FF-L-2937
AMENDMENT 2
February 1, 2007
SUPERSEDING
AMENDMENT-1
May 22, 2006

# FEDERAL SPECIFICATION

## COMBINATION LOCK, MECHANICAL

Figure 4

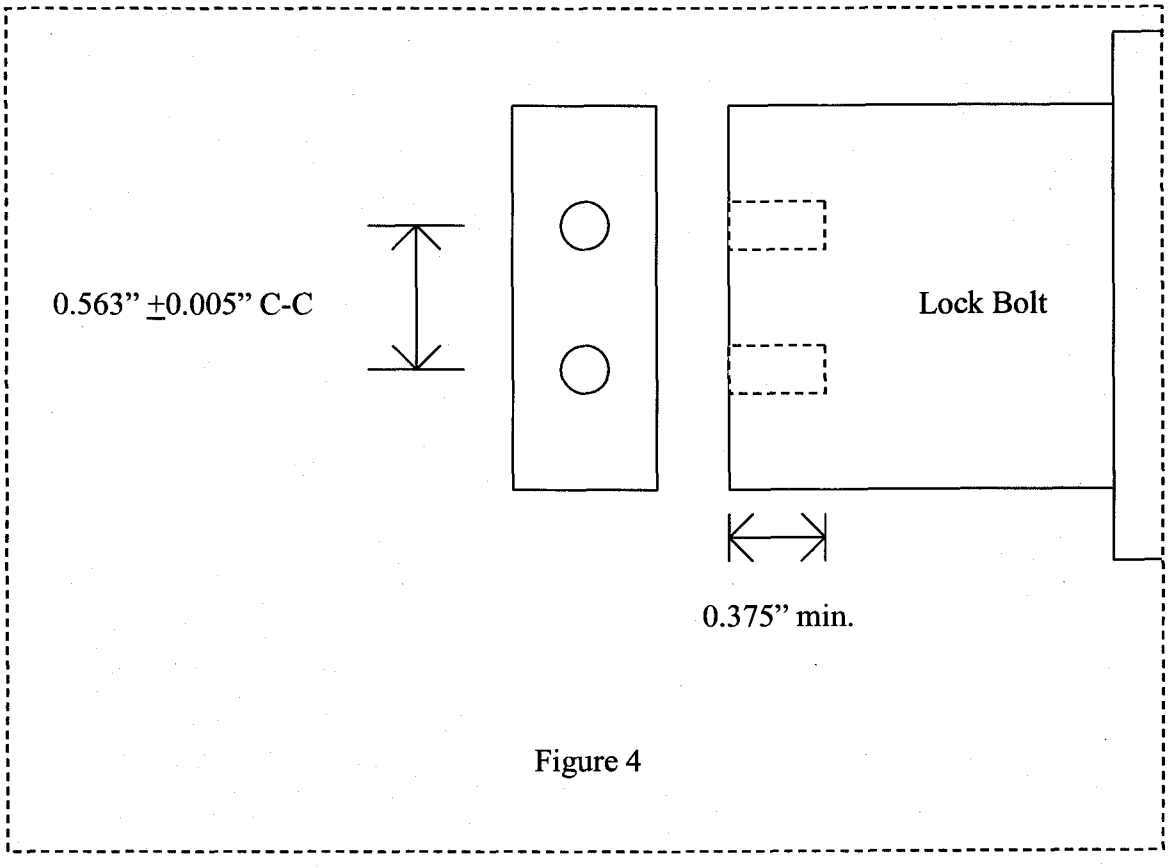
3.13.2 Bolt Design. The locking bolt shall have two threaded holes in the end of the bolt. The holes shall be #10-32 UNF with a center to center distance of 0.563 ± 0.005 inch. The holes shall be tapped to a minimum depth of 0.375 inch (see figure 4).

Add the following Figure to the end of the document:
